**BTRE
FOUR SPEED ELECTRONIC
AUTOMATIC TRANSMISSION
DEALER TRAINING SEMINAR
REVISION IV**

AUGUST 1994

Transmission Plant – Albury

FIGURE 1: SSV NOTCH DETAILS.

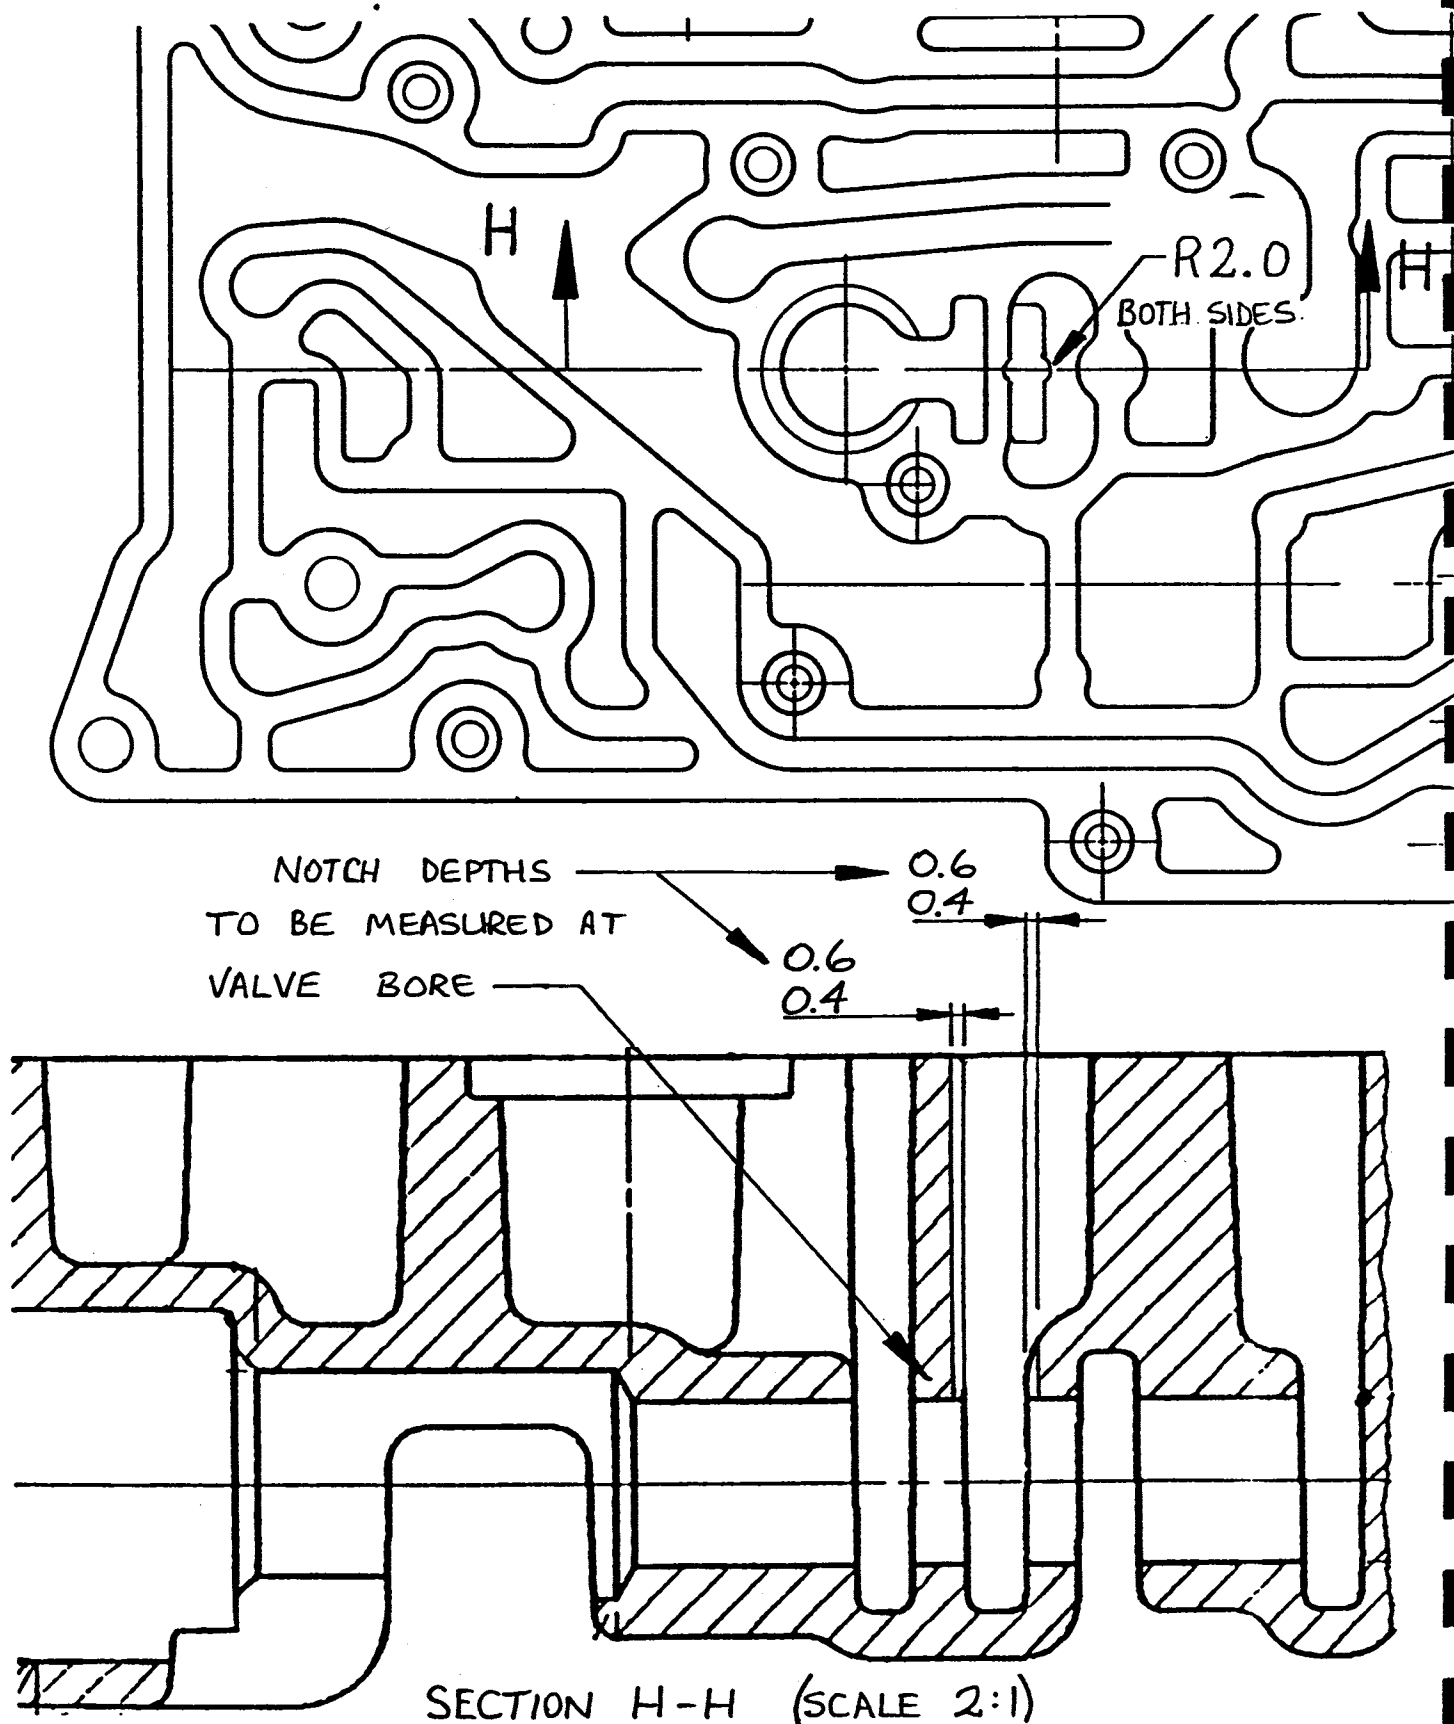
iii) Using a $\varnothing 4$ slot drill and milling machine, cut two 0.5mm deep notches as in Figure 1.

iv) Carefully re-assemble valve body ensuring that the solenoid supply valve moves freely in the modified bore.

FIGURE 2: LINE RELIEF VALVE ASSEMBLY.

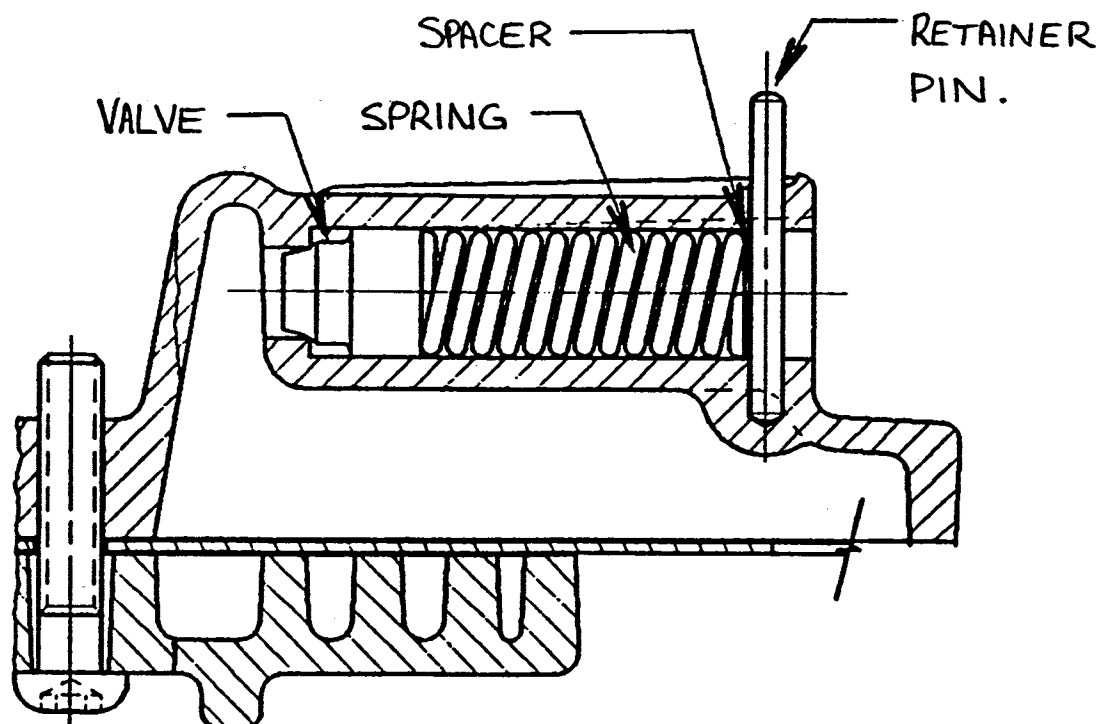
Transmissions built from February 1991 are assembled with line relief springs with non-ground ends (Part Number 0585-156143). This change is made to prevent valve buzz and also to increase reverse gear high line pressure.

- a) Remove pan and filter from transmission, do not remove valve body.
- b) Precompress line relief spring using a screw driver or similar tool and remove retainer pin.
- c) Remove spacer (if fitted), line relief spring and line relief valve. While the components are disassembled, check that the valve moves freely in the bore.
- d) Install valve, new spring 0585-156143 (non ground ends), 0.3mm thick spacer and retainer pin. Refer figure 2 below;

FIGURE 3: DIMENSION "X".

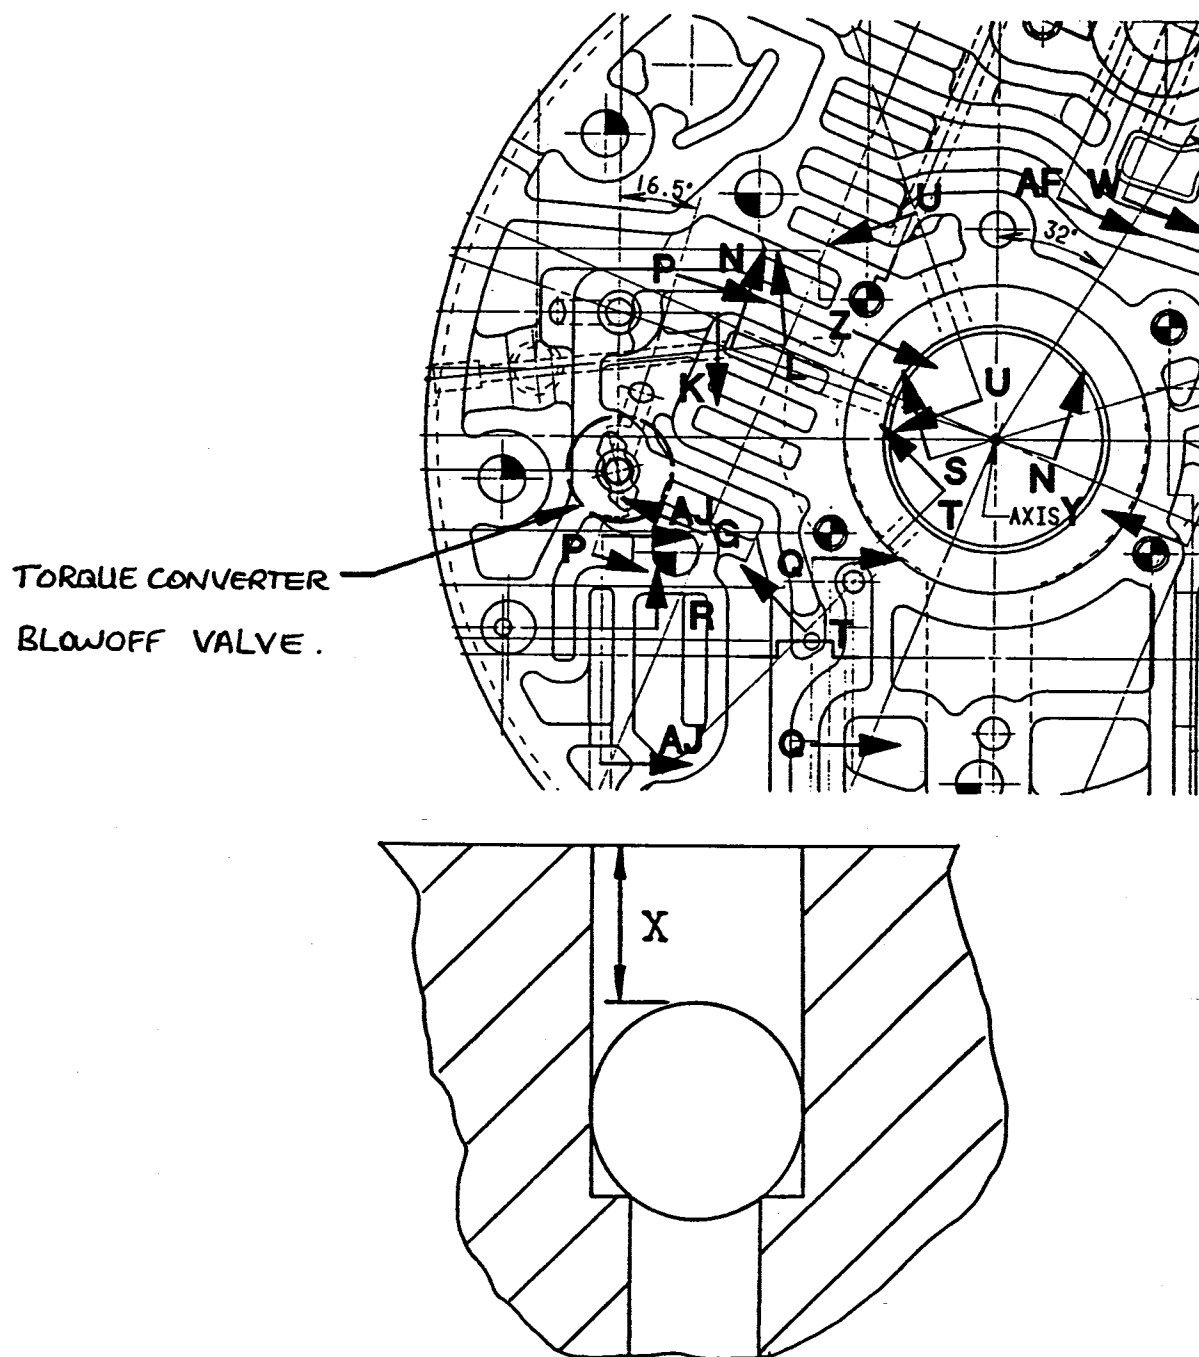
Transmissions built from May 10, 1990 are assembled with torque converter blow-off springs with non-ground ends (Part Number 0585-156136 and 0585-156137). This change is made to prevent torque converter blow-off noise and reduce pressure variations.

- f) Select the required spring load based on the following table;

FIGURE 4: MANUAL 1ST BLOW-OFF VALVE.

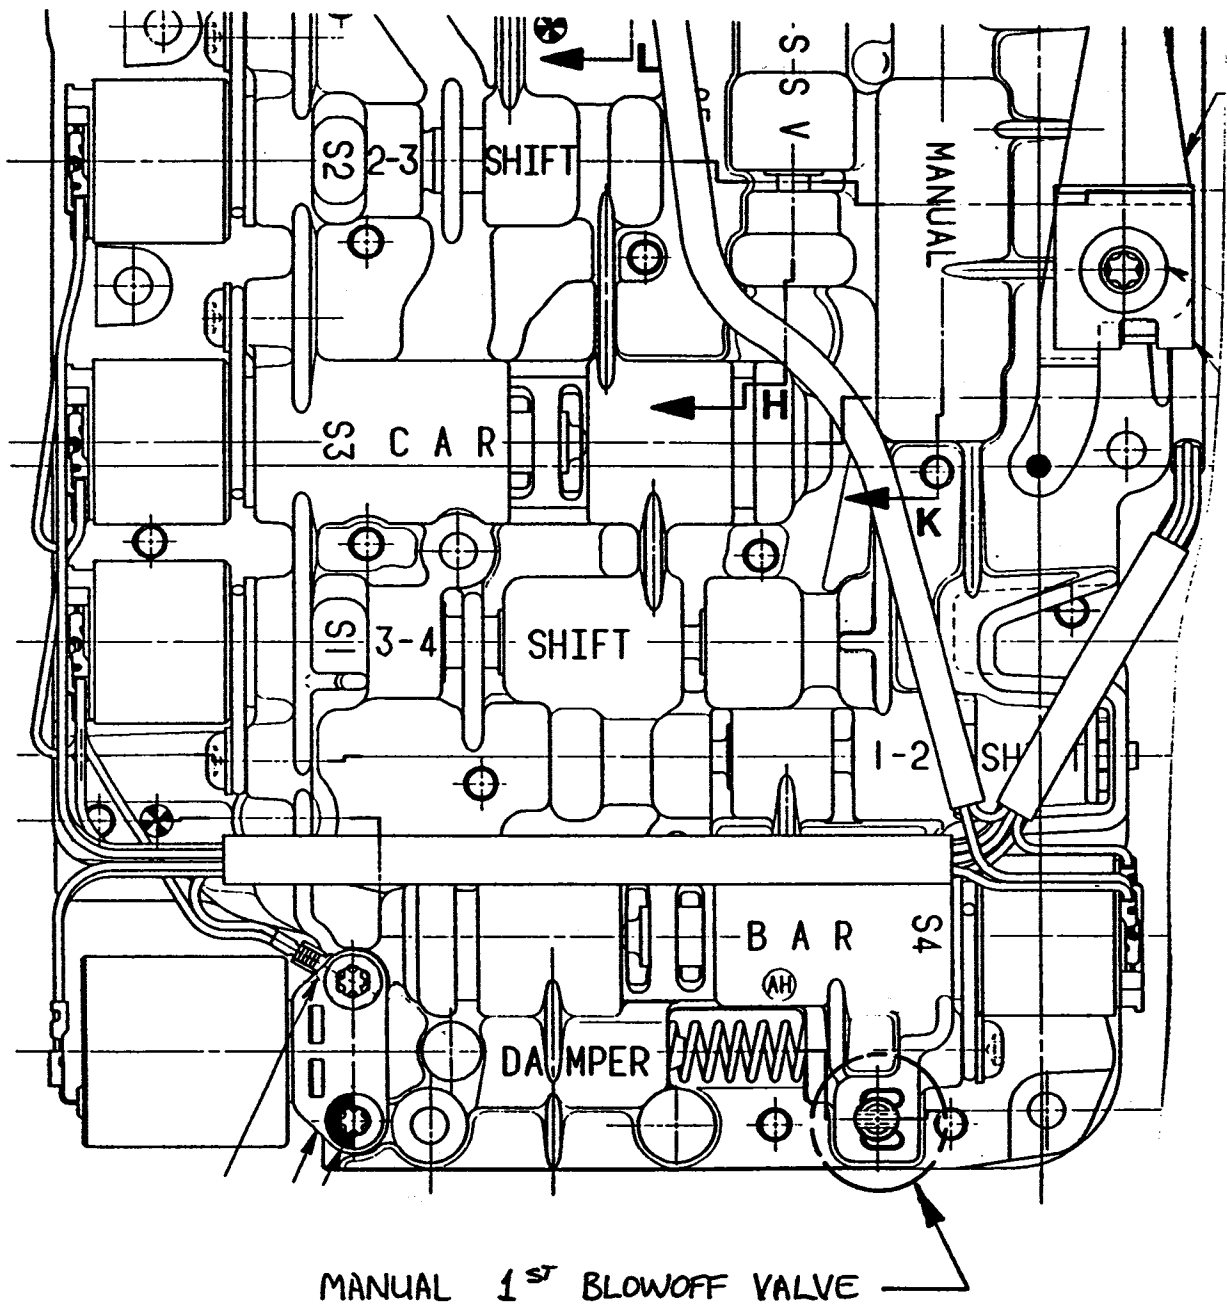
Transmissions built from December 1990 are assembled with manual 1st blow-off springs with non-ground ends. (Part Number 0585-156141). This change is made to prevent manual 1st blow-off valve buzz.

- d) Install, ball, new spring (0585-156141) and retainer. Refit valve body, filter and pan to the transmission.

FIGURE 1 - c2 FRICTIONS ONLY

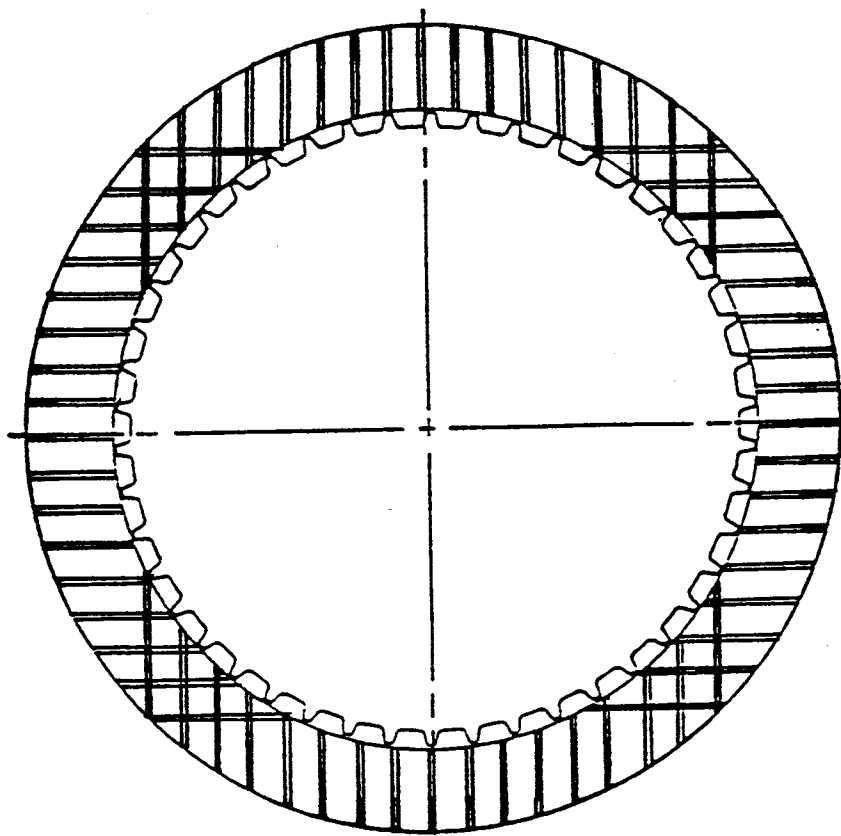
FRICTION PLATES WITH GROOVE DETAILS AS SHOWN IN FIGURE #1 SHOULD ONLY BE USED IN THE C2 CLUTCH PACK.

FIGURE 2 - c1, c3 & c4 FRICTIONS

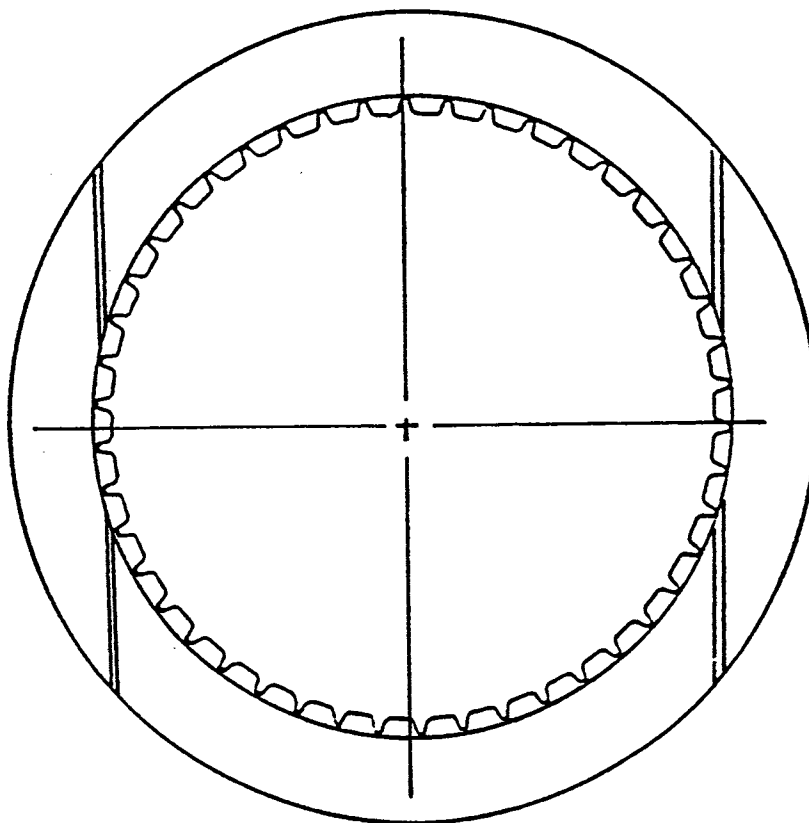
C1, C3 and C4 CLUTCH PACK ASSEMBLIES SHOULD ONLY USE FRICTION PLATES WITH GROOVE DETAILS AS SHOWN IN FIGURE #2.

FIGURE 1: SSV NOTCH DETAILS.

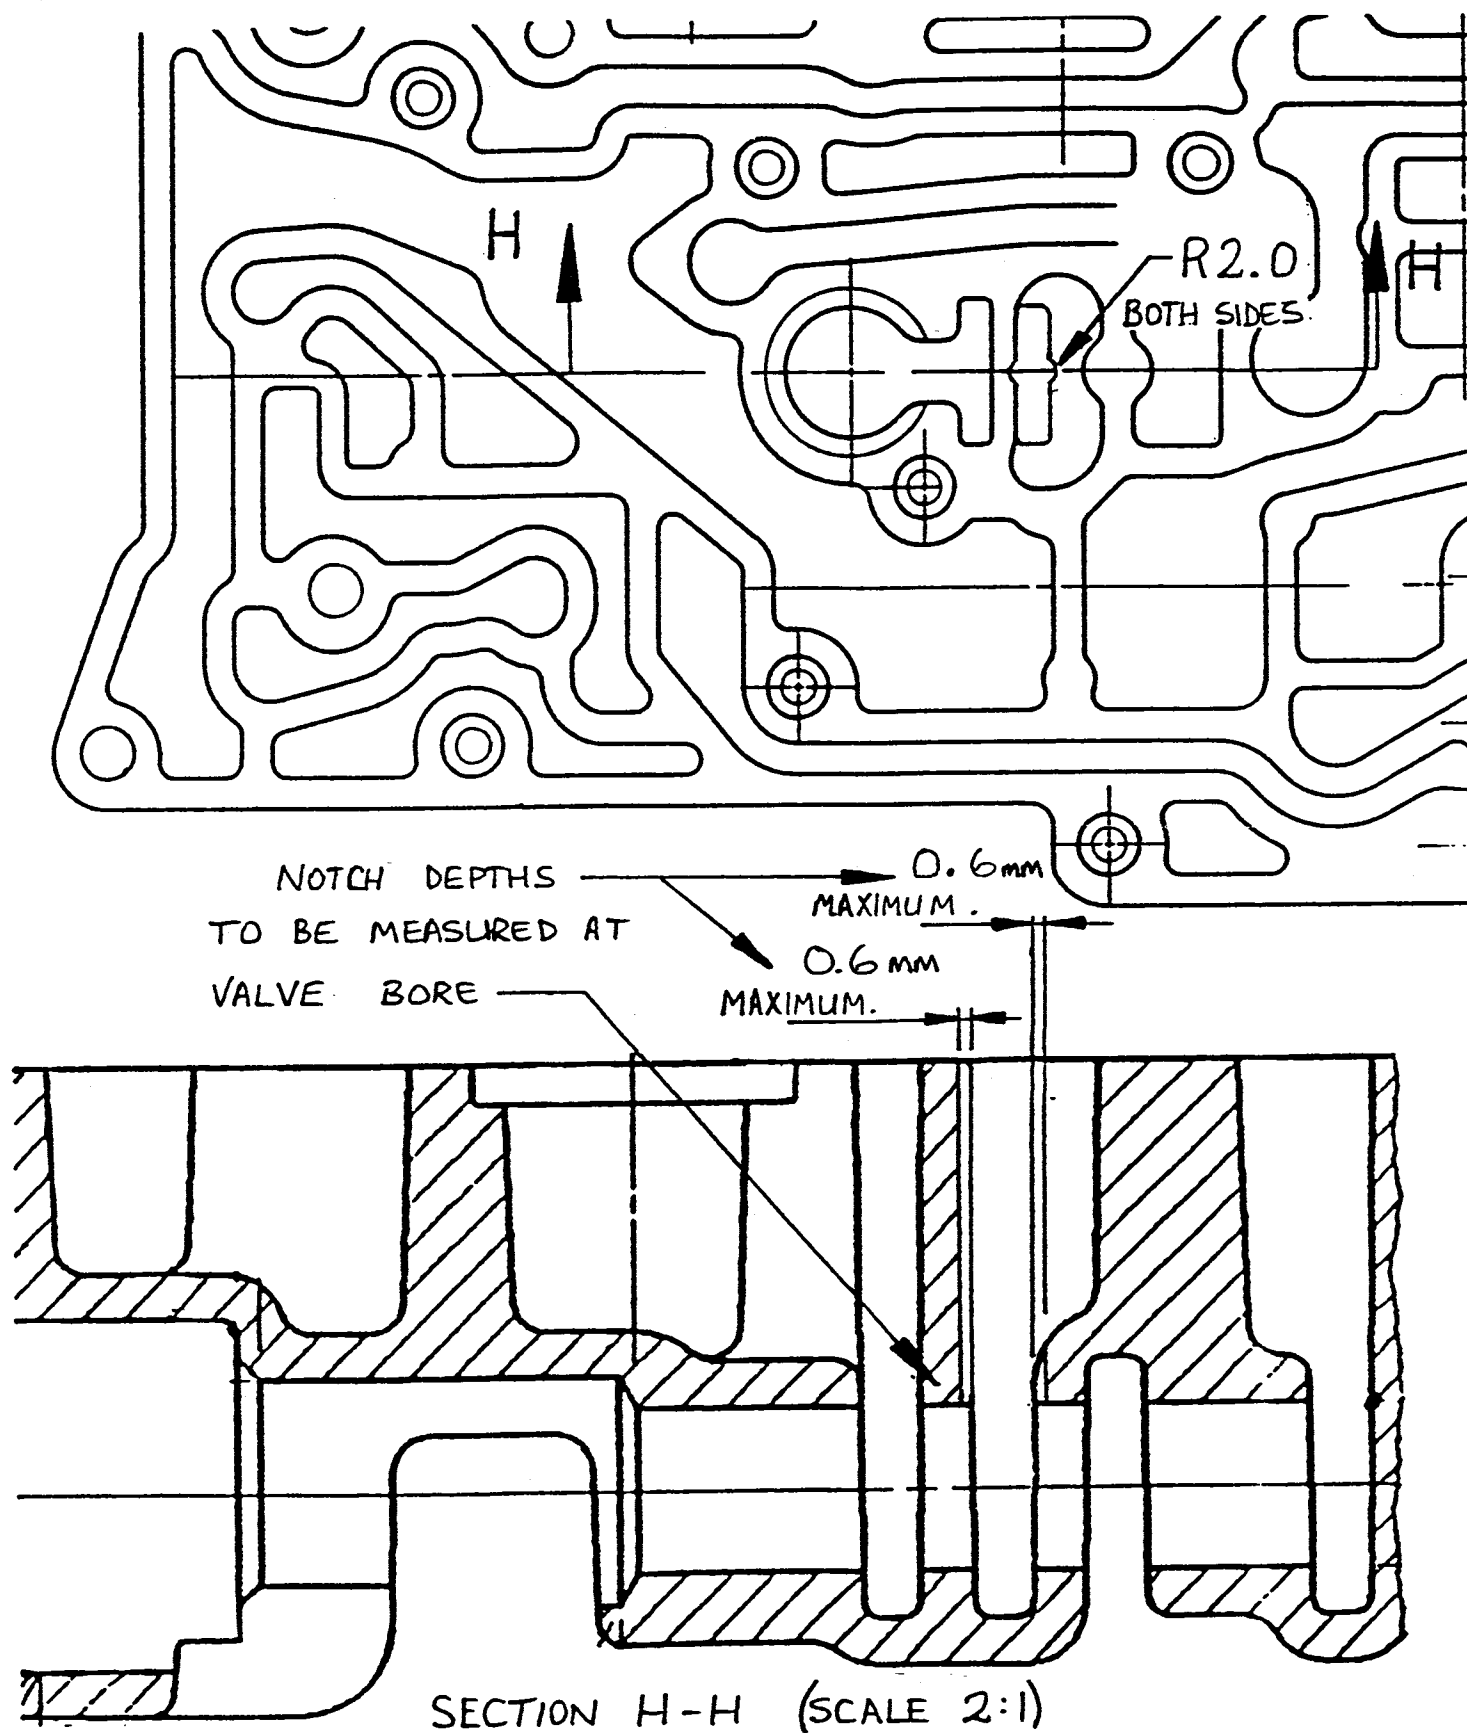
- i) Remove valve body assembly from transmission.
- ii) Fully disassemble the valve body.
- iii) Use a $\varnothing 4$ round file to cut two 0.6mm maximum deep notches as shown in Figure 1.

- iv) Carefully reassemble the valve body ensuring that the solenoid supply valve moves freely in the modified bore.

FIGURE 2: ASSEMBLY OF NEW S5 DAMPER COMPONENTS.

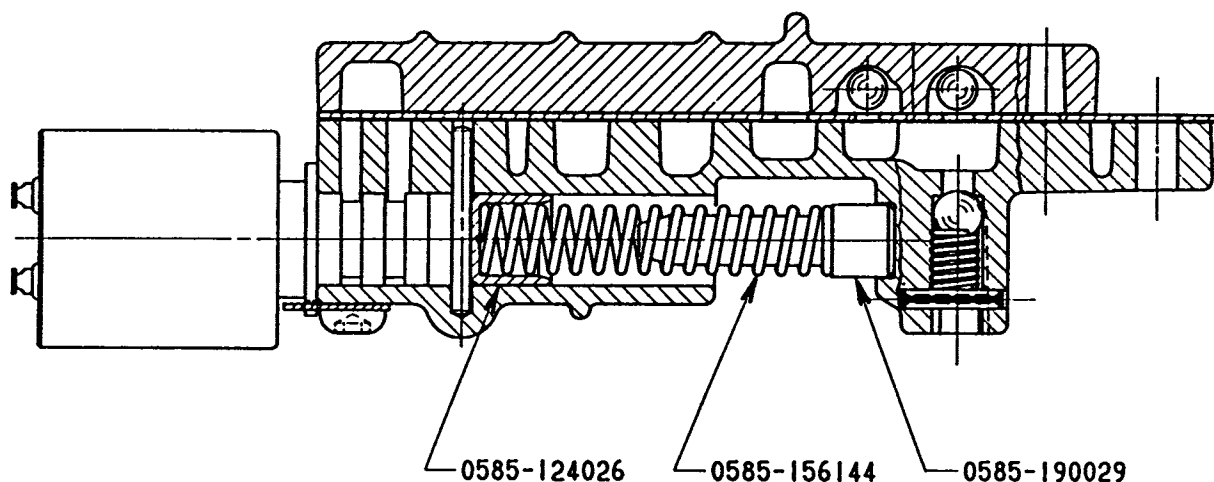
This upgrade will help to stabilize S5 circuit pressure and increase VPS life.
